APPENDIX A

MODEL REVIEW

A1 DARLINGTON POINT FLOOD STUDY

MODEL REVIEW

Plate A1 XP-RAFTS Model sub-catchment delineation for the 'Murrumbidgee River at Darlington Point and Environs Flood Study' (2018)

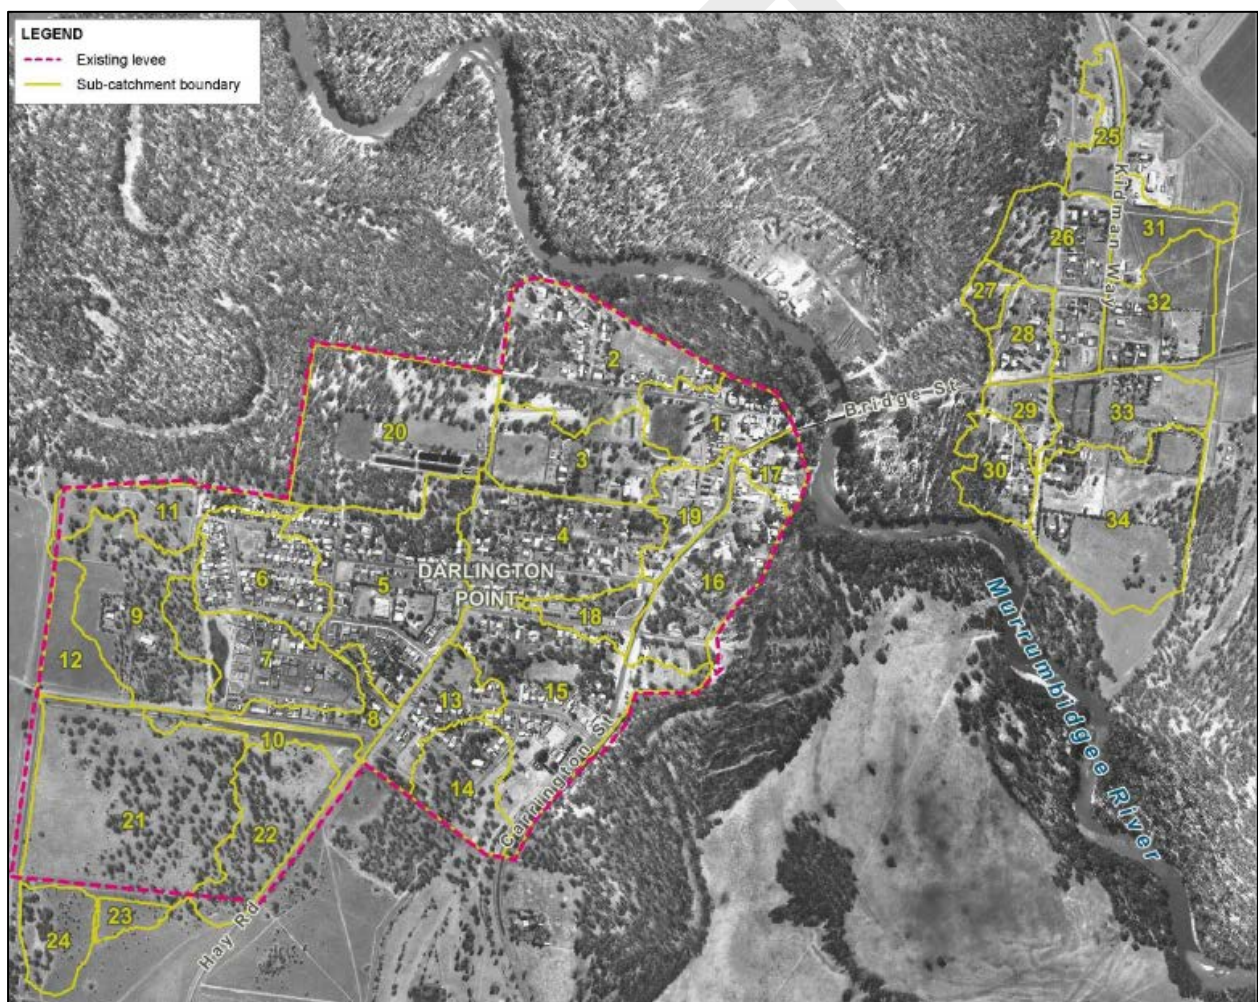
The XP-RAFTS model comprises 23 local sub-catchments at Darlington Point and 10 sub-catchments at North Darlington Point, as shown in **Plate A1**. No discussion is included in the

flood study regarding how subcatchment boundaries were delineated. However, the subcatchment boundaries were compared to ground surface elevations within the 1m x 1m gridded DEM derived from NSW LPI LiDAR survey. On this basis, the alignment of the subcatchment boundaries appear to be reasonably defined.

The report also documents that it was assumed that around 25% of each sub-catchment was comprised of impervious surfaces (roads, roofs etc.) based on analysis of a sample of aerial photography of the town. Therefore, an impervious sub-area equal to 25% of the total subcatchment area was applied to subcatchments 1 to 19 that are located within the levee and comprise a reasonable degree of urbanisation. It is recommended that these values be reviewed

and specific values for the pervious/impervious subareas within each sub-catchment be applied in order to provide the best description of hydrologic processes across the sub-catchments within the levee.

It was also noted that a pervious “n” (PERN) value of 0.06 was adopted for pervious sections of each subcatchment, while a PERN value of 0.025 was adopted for impervious sections of each subcatchment. As impervious surfaces (e.g., roads, concrete) will have a lower roughness relative to pervious sections of the catchment (e.g., grass, shrubs, trees), the use of different PERN values is appropriate. However, it is suggested that the PERN values could be modified to better reflect the different resistance to flow afforded by the pervious/impervious areas. The XP-RAFTS User Manual suggests a PERN value of 0.015 for impervious sub-areas. For pervious areas, it is recommended that a weighted average PERN value be calculated for each sub-catchment based on the constituent land uses/material types within each area. Therefore, it is recommended that the PERN values used in the model be reviewed and revised, as appropriate.
